TO: HONORABLE CHAIRMAN AND PLANNING COMMISSION
FROM: RON WHISENAND, COMMUNITY DEVELOPMENT DIRECTOR
SUBJECT: TENTATIVE PARCEL MAP PR 07-0275, AT 105 CAPITOL HILL
(APPLICANT: RICHARD COOK)
DATE: JUNE 10, 2008

RESOLUTION NO. _____
A RESOLUTION OF THE PLANNING COMMISSION
OF THE CITY OF EL PASO DE ROBLES
TO GRANT TENTATIVE MAP APPROVAL FOR
PARCEL MAP PR 07-0275
(RICHARD COOK)
APN: 009-523-003

TENTATIVE RECORD MAP 07-0275
 DIVISION OF LOT 5 AND A PORTION OF LOT 6
 CAPITOL HILL DRIVE, COUNTY OF CALIFORNIA,
 MAPS IN THE OFFICE OF THE COUNTY RECORDER, COUNTY OF
 CALIFORNIA, SAN JOSE, STATE OF CALIFORNIA.
RECEIVED

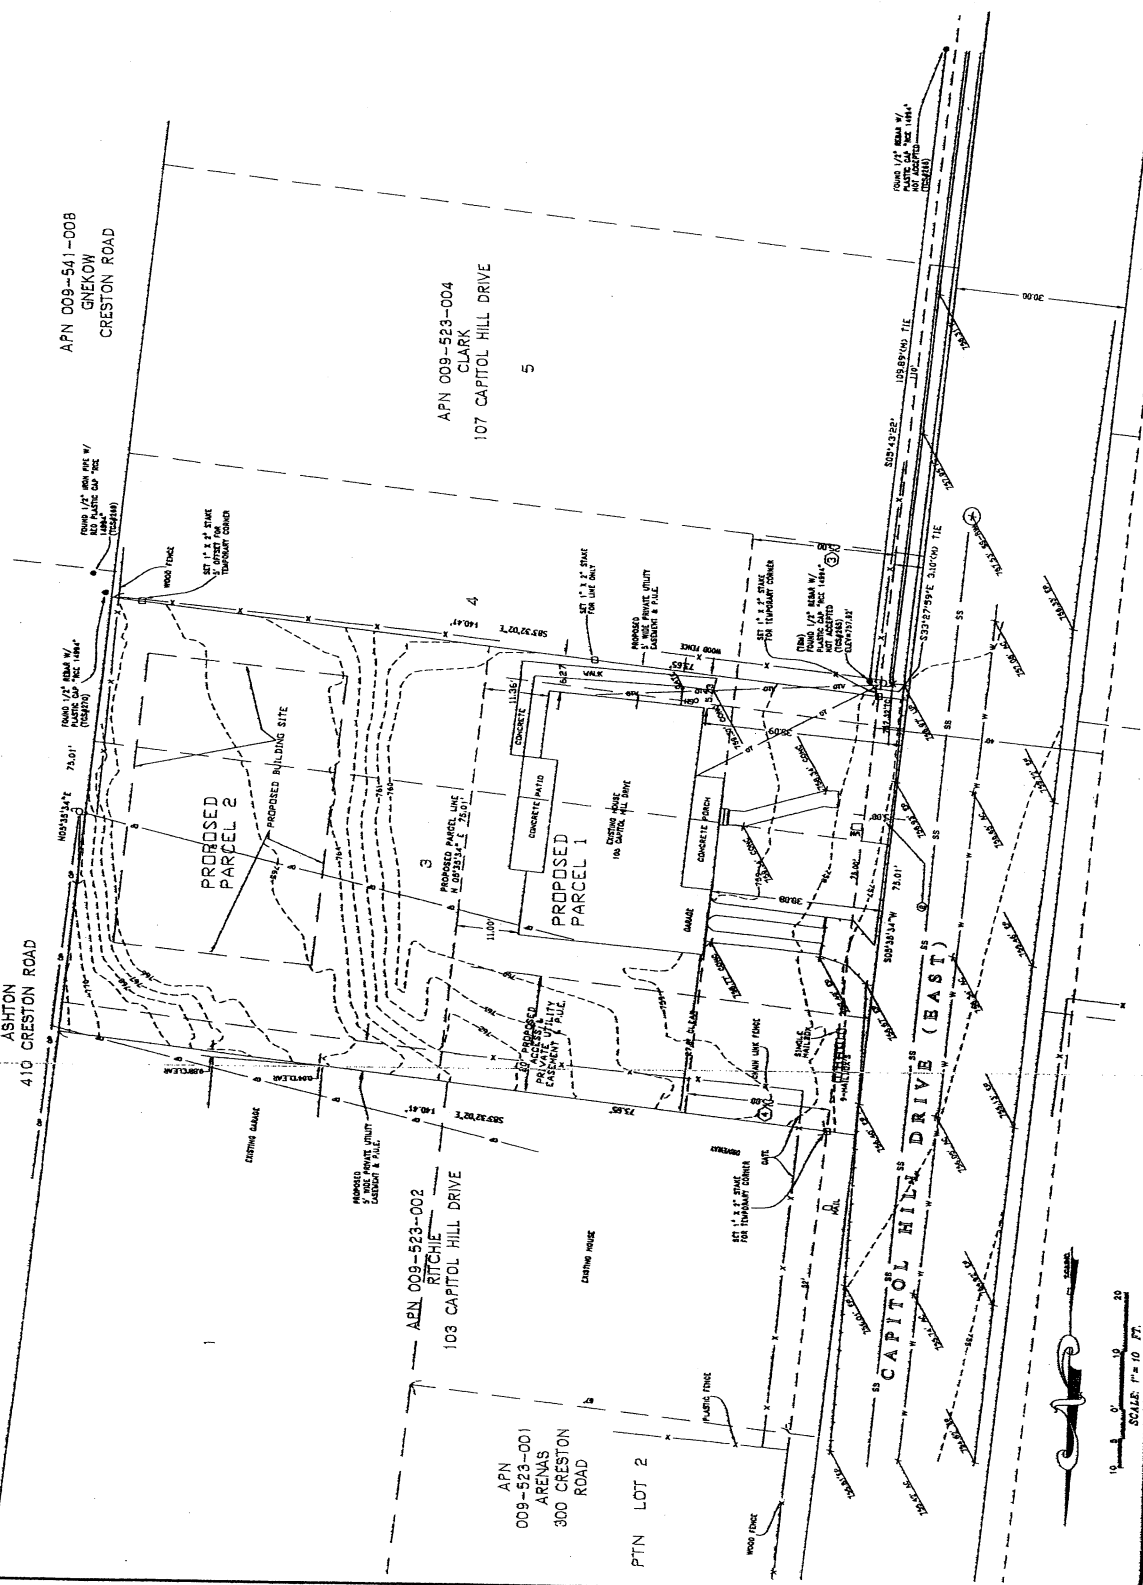
The subject property is located on the east side of the east leg of Capitol Hill Drive. Capitol Hill Drive is classified as a local street in the Circulation Element of the General Plan.

Curb and gutter will be required. Sidewalk has typically been waived on Capitol Hill Drive due to the narrow right-of-way and topographic issues on other sections of the street. We recommend installation of a five-foot sidewalk in this case, with the anticipation that the sidewalk could be extended to Creston Road in the future.

A 6-inch water line serves the properties on Capitol Hill Drive. The nearest fire hydrant is located at the corner of Creston Road. Another fire hydrant is needed roughly 300 feet south of that location.

There is a 6-inch sewer line located adjacent to the property on Capitol Hill Drive.

Prior to recordation of the final map, the applicant shall dedicate right-of-way 20 feet from the centerline of Capitol Hill Drive.

Prior to recordation of the final map; curb, gutter sidewalk and paving shall be constructed on Capitol Hill Drive in accordance with plans approved by the City Engineer.

Prior to recordation of the final map, a fire hydrant shall be installed on Capitol Hill Drive approximately 300 feet south of Creston Road.

Individual water and sewer services shall be provided to each parcel. The final parcel map shall include all utility easements necessary, including easements for water and sewer services to each parcel.

Prior to final map approval, overhead utilities serving the existing residence shall be relocated underground. The applicant shall enter into an agreement not to protest the formation of an assessment district to underground existing overhead public utilities in the block.
